CORD	REV	REVISION RECORD	AUTHORITY	DATE
	A	PRODUCTION RELEASE	W.C.	01-94
	B	ECO 3419	W.C.	3-94
	C	ECO 3450	W.C.	3-94
	D	ECO 3517	W.C.	4-94
	E	ECO 3525	W.C.	4-94
	F	ECO 3572	W.C.	8-94
	G	ECO 3617	W.C.	9-94
	H	ECO 3640	W.C.	10-94
	I	ECO 3654	W.C.	12-94
	J	ECO 3667	W.C.	10-94
	K	ECO 3673	W.C.	12-94
	L	ECO 3678	W.C.	10-94
	M	ECO 3699	H.M.	12-94
	N	ECO 3700	H.M.	12-94
	O	ECO 3701	H.M.	12-94
	P	ECO 3737	H.M.	12-94
	Q	ECO 3818	H.M.	5-95
	R	ECO 3854	H.M.	5-95
	S	ECO 4083	H. M.	11-95

DWN	C.C.	9-93	ROCKFORD FOSGATE CORPORATION DIVISION TEMPE AZ		
CHK					
ENGR	C.C.	9-93	TITLE SERIES ONE 2300 SCHEMATIC		
APVD					
APVD			SIZE B	SCALE	SHEET 1 OF 2
MATL/FS			FILE NAME SCH0511F	PART NO. SCH-0511-F	REV S

DWN	C.C	9-93	ROCKFORD FOSGATE DIVISION TEMPE AZ CORPORATION	
CHK				
ENGR	C.C	9-93	TITLE: SERIES ONE 2300 SCHMATIC	
APVD				
APVD			SIZE B	SCALE: SHEET 2 OF 2
MATL/FS			FILE NAME: SCH0511F	PART NO.: SCH-0511-F REV S

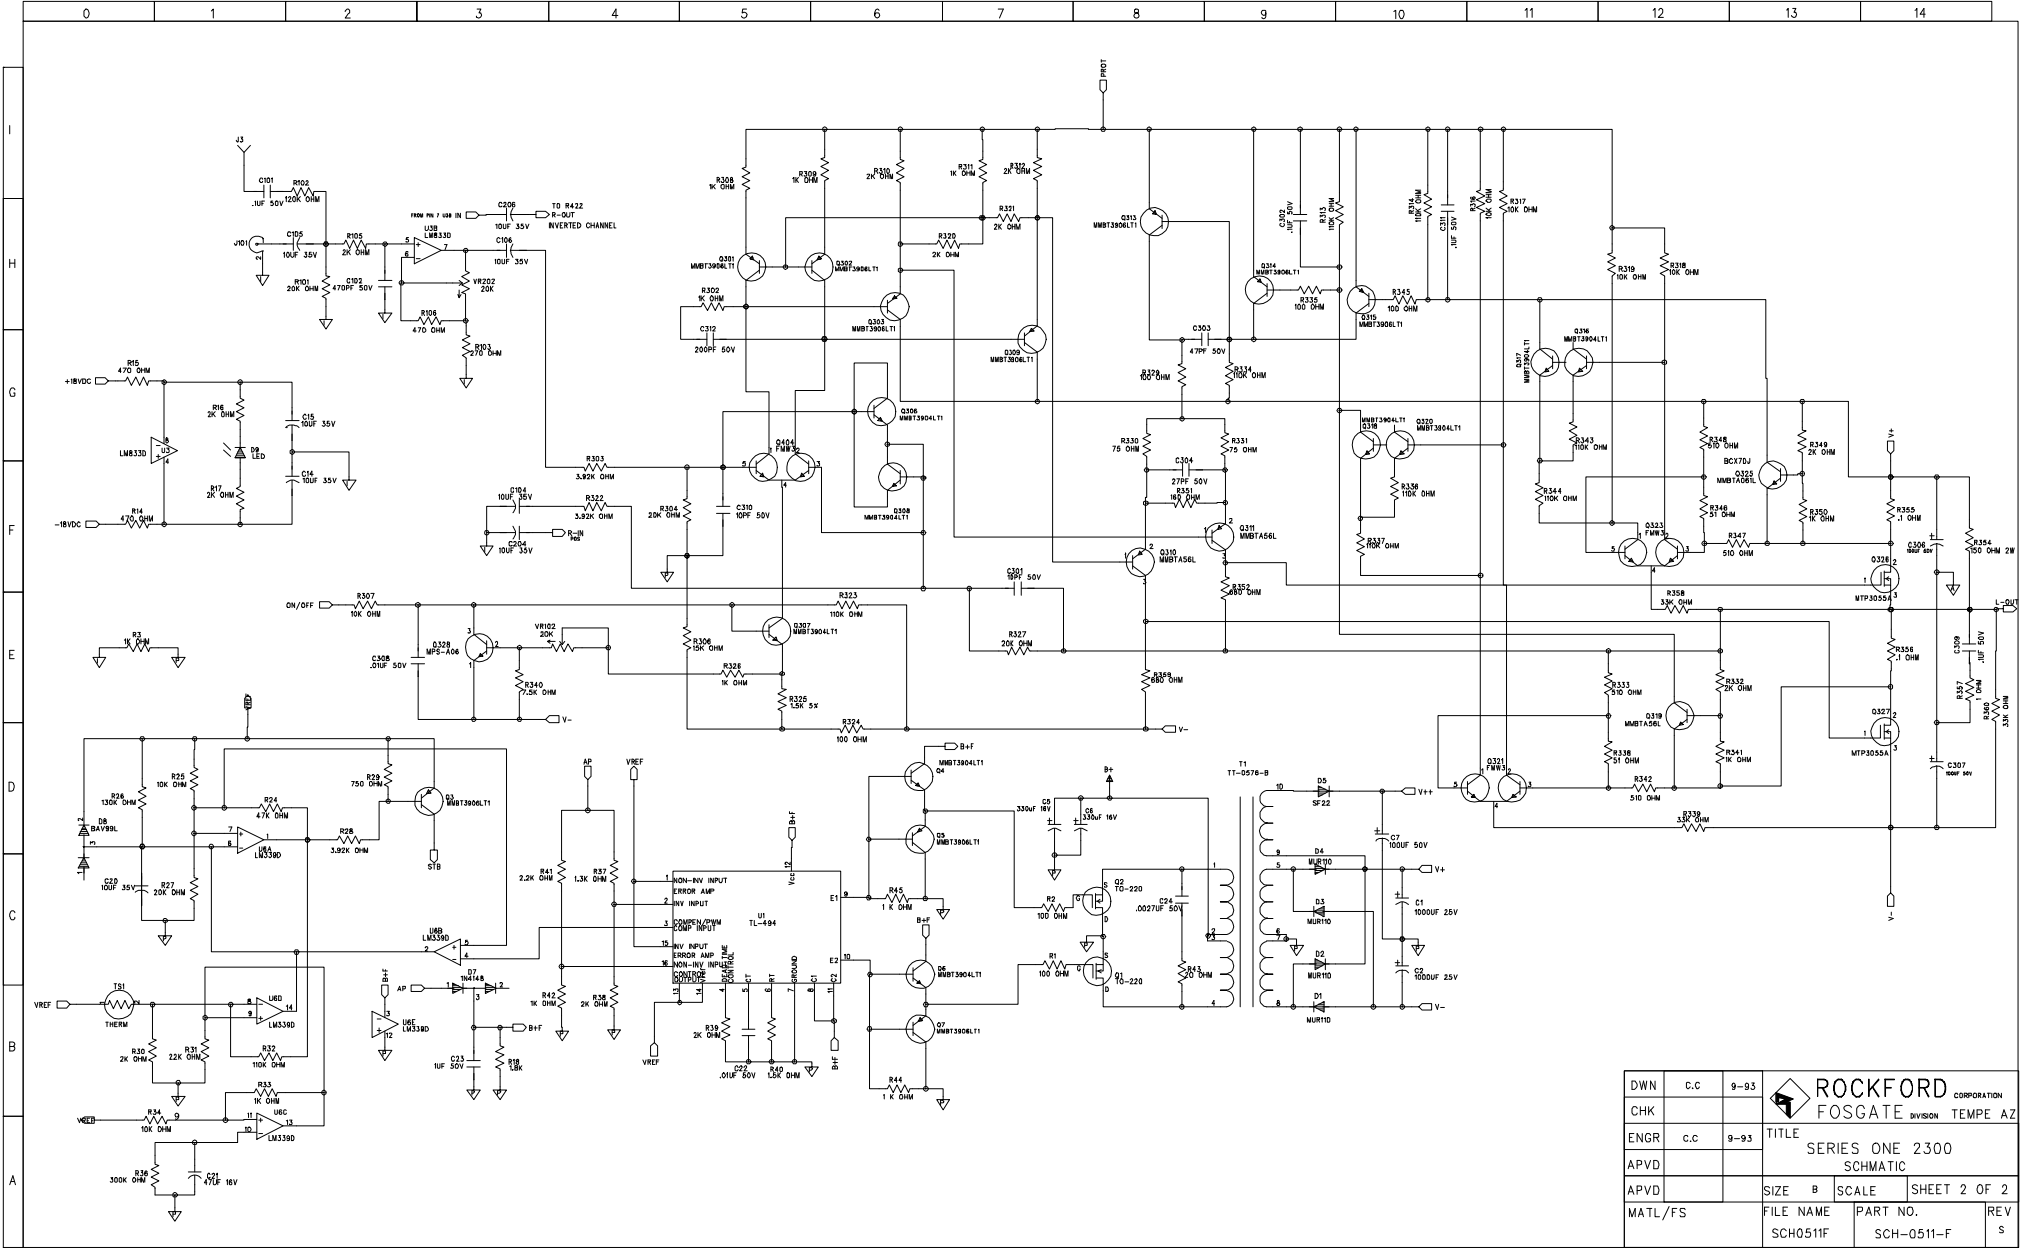
NOTES
FOR REF DES Q4, 6, 306, 307,
308, 316, 317, 318, 320
PRIMARY PART # BCX70J
SECONDARY PART # BC846BL
PER ECO 3419

PRIMARY PART # SS-802SM TL494
SUBSTITUTE PART # SS-0722 TL594
PER ECO 3450

SS-760-047 HAS BEEN CHANGED
REF DES Q1 2
NEW PART # SS-760-046
PER ECO 3617

SS-731-047 HAS BEEN CHANGED
REF DES Q326 327 426 427
NEW PART # SS-731-046
PER ECO 3617

SS-731 (MTA3055E) HAS BEEN
REPLACED. REF DES Q326 327 426 427
NEW PART # SS-257 (MTP3055E)
PER ECO 3699

PART # RM/4-203C 20K 5% HAS BEEN
REPLACED. REF DES R340 R440
NEW PART # RM/4-752C 7.5K 5%
PER ECO 3525

PART # RM/10-821B 820 OHM 5% HAS BEEN
REPLACED. REF DES R325 R425
NEW PART # RM/10-152B 1.5K 5%
PER ECO 3517

SS-209SM (BCX70J) HAS BEEN REPLACED
REF DES Q4 6 306 307 308 316 317 318 320
NEW PART # SS-0792 (MMBT3904LT1)

SS-210SM (BCX71J) HAS BEEN REPLACED
REF DES. Q3 5 7 301 302 303 309
312 313 314 315
NEW PART # SS-0791 (MMT3906LT1)
NEW PART # SS-204SM (MMBT5401L)
FOR REF DES 312
PER ECO 3572

RM/10-105B (1M 5%) REF DES R35
HAS BEEN REMOVED PER ECO 3640

CERHF-337I (330UF 16V) HAS BEEN
REPLACED. REF DES C5 6
NEW PART # CERHF-337BL (330UF 35V)
PER ECO 3667

REPLACE RM/10-272B (2.7K)
REF DES R302 R402
WITH RM/10-102B (1K)
REPLACE CDS-101CAAA
REF DES C312 C412
WITH CDS-221CAAA
PER ECO 4083

SS-760-046 HAS BEEN CHANGED
REF DES Q1 2
NEW PART # SS-RFP15N06 (TO-220 HARRIS)
PER ECO 3678

SS-260SM (BAV99L) HAS BEEN CHANGED
REF DES D7
NEW PART # SS-162-051 (IN4148)
PER ECO 3654

CERHF-337BL-024 (330uf 16v) HAS
BEEN REPLACED. REF DES C5 6
NEW PART # CERHF-337I-024 (330uf 16v)
PER ECO 3673

SS-760-046 (MTA15N06) HAS BEEN
REPLACED. REF DES Q1, 2
NEW PART # SS-0936-046 (MTAJ27N06E)
PER ECO 3700

SS-0936 (MTAJ27N06E) HAS BEEN
REPLACED. REF DES Q1 2
NEW PART # SS-RFP15N06 (TO-220 HARRIS)
PER ECO 3701

SS-204SM (MMBT5401L) HAS BEEN DELETED
REF DES Q312 412
RM/10-114B (110K) HAS BEEN DELETED
REF DES R328 428
PER ECO 3737
